Austin Water Utility

A RENOVATION FOR

CHERYL & JOHN SAUDER  
1616 NORTHUMBERLAND RD  
AUSTIN, TX 78703

PERMIT

PROPOSED SITE PLAN

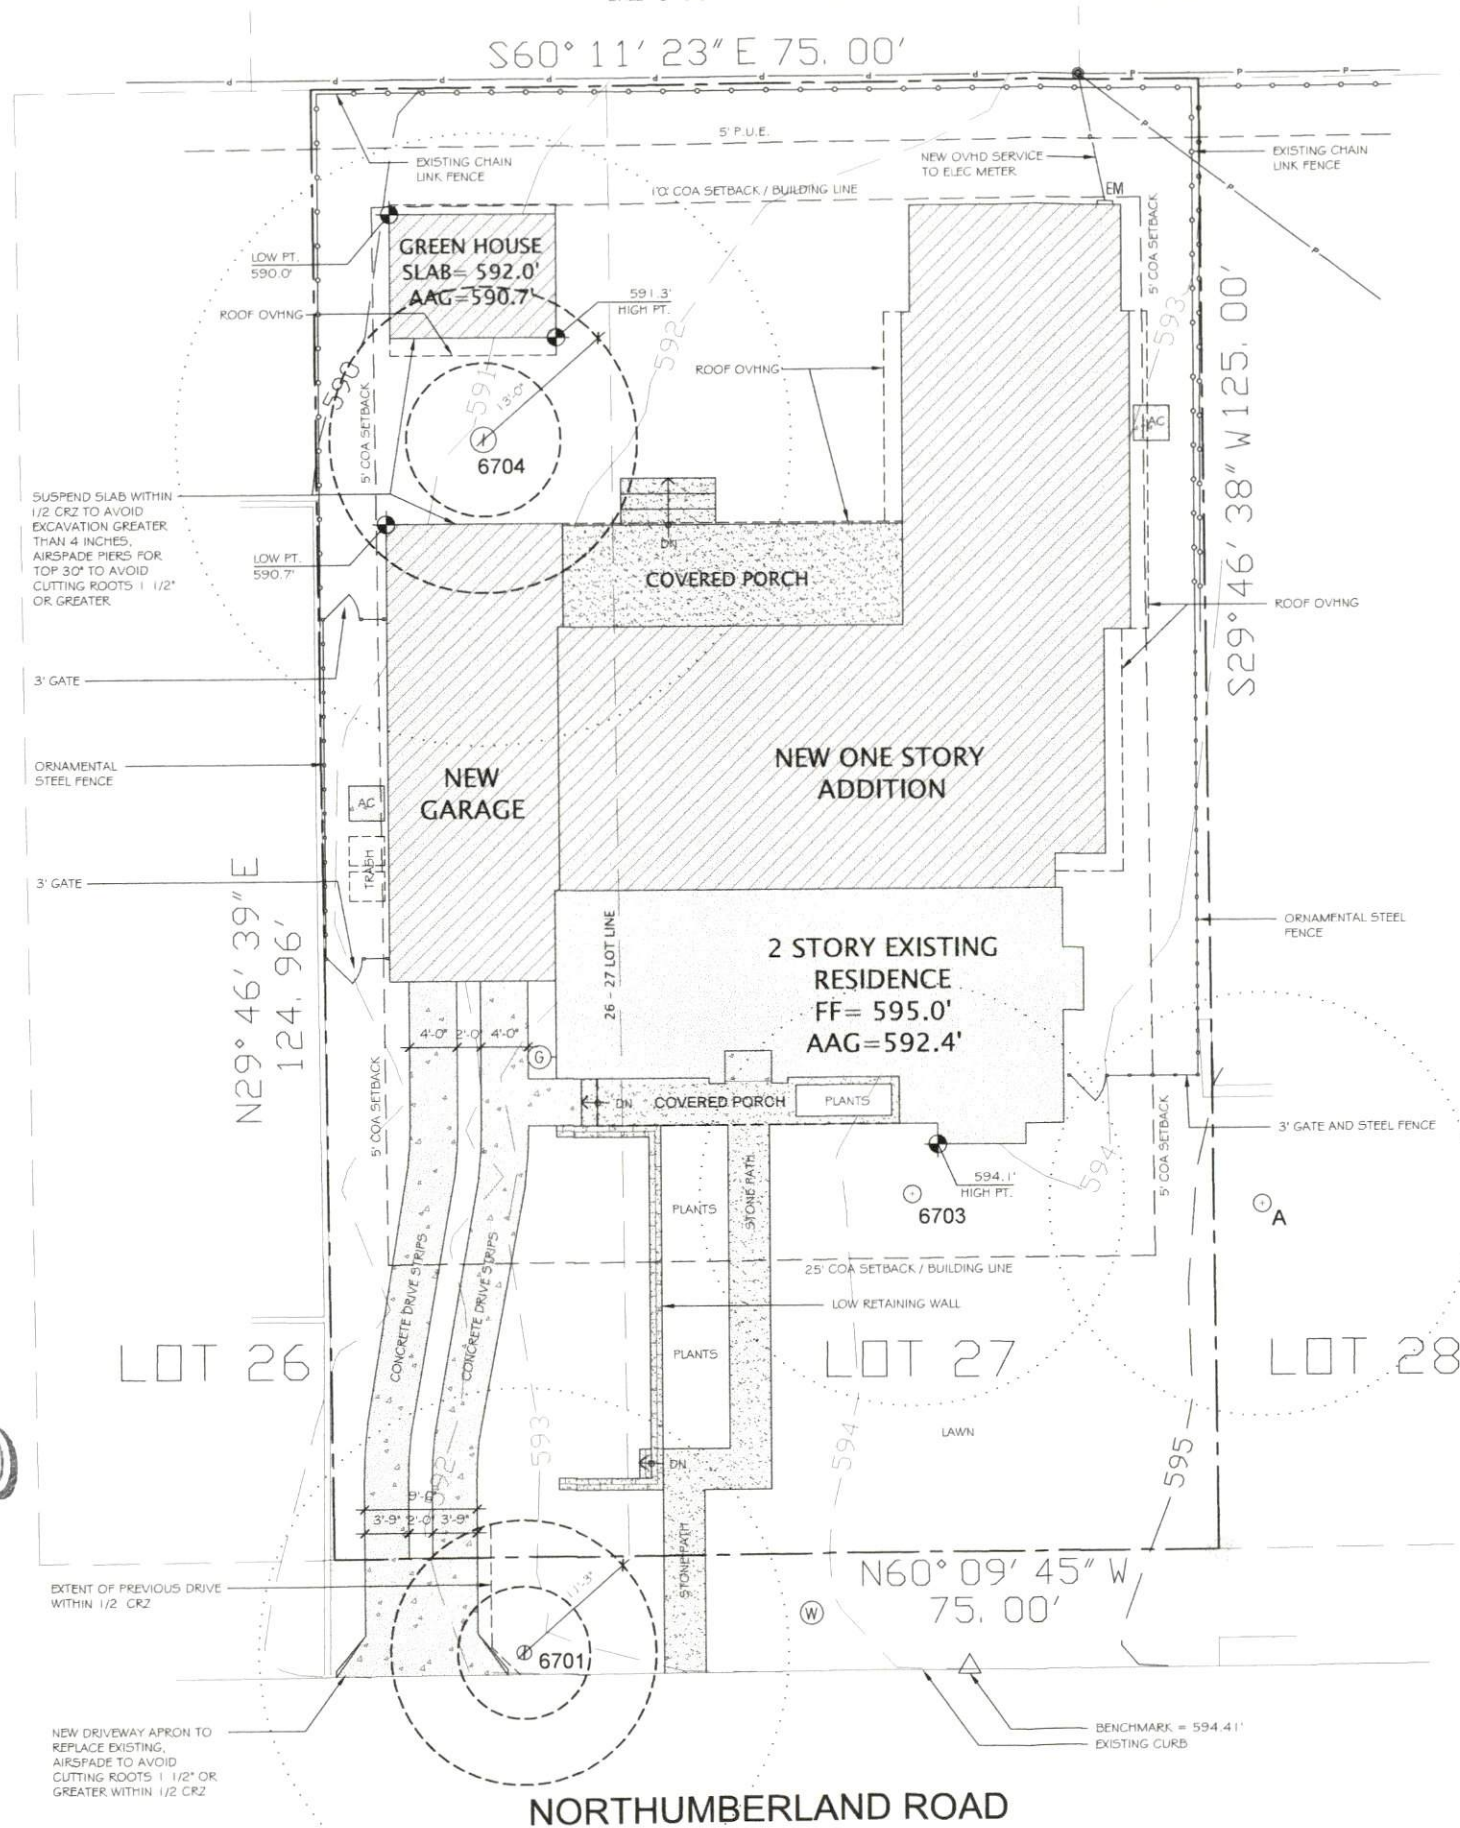
All structures must maintain 7'6" clearance from AE energized distribution power lines. Enforced by AE and NESC codes-this review DOES NOT include transmission power lines.
